### **Addendum 53 – Regulation No. 54**

### **Revision 3 - Amendment 3**

### **Uniform provisions concerning the approval of pneumatic tyres for commercial vehicles and their trailers**

Annex 2, amend to read:

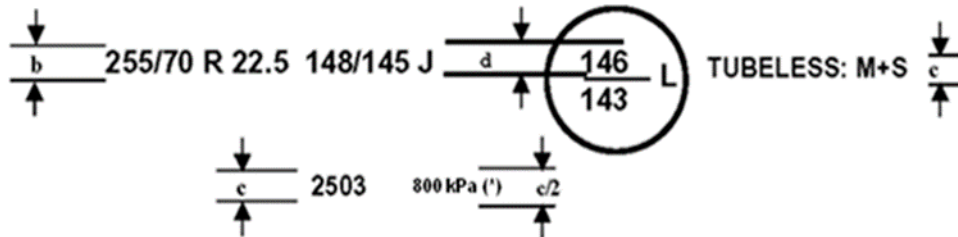
The above approval mark affixed to a tyre shows that the type of tyre concerned has been approved in the Netherlands (E 4) under approval number 002439. The first two digits of the approval number indicate that the approval was granted in accordance with the requirements of Regulation No. 54 in its original form..."
